Thomas Bell North Somerset Council Walliscote Grove Rd Weston-super-Mare BS23 1UJ

28th February 2024

Thank you for the response received in relation to Land North of Rectory Farm, Yatton; planning ref: 23/P/0664/OUT. I was pleased to see that you have had the chance to review the report and wanted to provide clarifications on some of the points raised.

# 1. Lighting

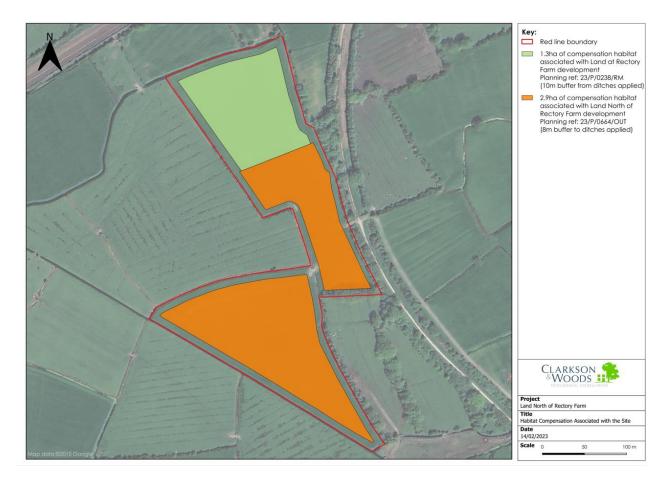
I concur with Natural England's comments that additional information regarding light spill should be provided. To inform the HRA and provide a worst-case scenario which demonstrates that sufficiently low levels of lighting can be achieved, all areas of external lighting should be modelled and where windows and glazing from properties are in close proximity facing the areas included into the HEP calculations as depicted in figure 6 of the sHRA internal lighting should be modelling to provide indicative light spill onto the surrounding habitat. Considering in all scenarios modelled for vertical light spill where planes B and E fail in the Lighting Scheme and Assessment dated 24th march 2023 by e3 consulting engineers the areas within the centre of the site should not be counted as accessible to horseshoe bats within the HEP calculation (and would require additional areas to be used in the offsite location as compensation habitat), unless it can be demonstrated that mitigation in the form of close-board fencing would not result in unacceptable light spill in these areas.

The exclusion of habitat from the HEP calculations have been undertaken on the basis of the worst-case scenario of the horizontal plane calculations from the street lighting and security lighting specified. Select vertical planes were modelled to test the feasibility of culvert crossing points which if functional would have allowed horseshoe bat to access another area of grassland along with ditches and hedgerows to the east of the access road. As illustrated by vertical planes A-E in the initial lighting assessment, these potential crossing points are illuminated to above 0.5 lux in the area alongside the culvert entrances. As a consequence, all habitat to the east of the access road and any habitat illuminated alongside the culvert were excluded from the habitat included in the HEP calculations. This includes a fringe of habitat to the culverts which was illustrated as being illuminated above 0.5lux in the worst-case vertical plane calculations. It should be noted the vertical planes illustrated the corridors where they are situated away from the culvert entrances were unlit from the proposed street and security lighting. As such the corridors where unlit are available to horseshoe bats for foraging.

Internal light spill assessment is unfeasible at the outline stage due to the need to model the internal dimensions of each dwelling which are currently unspecified. It is agreed that modelling of internal lighting from dwellings which face onto proposed mitigation land should be undertaken to ensure the full quantum of mitigation habitat required can be delivered without impacts from internal lighting. However, in the absence of being able to progress an internal lighting assessment a 10m buffer from each house facing directly onto the habitat has been applied to ensure that light can dissipate adequately and negate the need to undertake further internal light calculations at this stage. Including the exclusion of the habitats within 10m of the dwellings the proposals remain compliant with the habitat provision for both species of horseshoe bat. Adjustments have been made to the HEP calculations to exclude an additional 800m2 of grassland and 428m2 of SuDs habitat as a result of a 10m buffer from each building facing the mitigation habitat and security lighting impacts being applied. The changes to the HEP calculations result in the proposals delivering 0.02 gain in equivalent hectares for greater horseshoe bats.
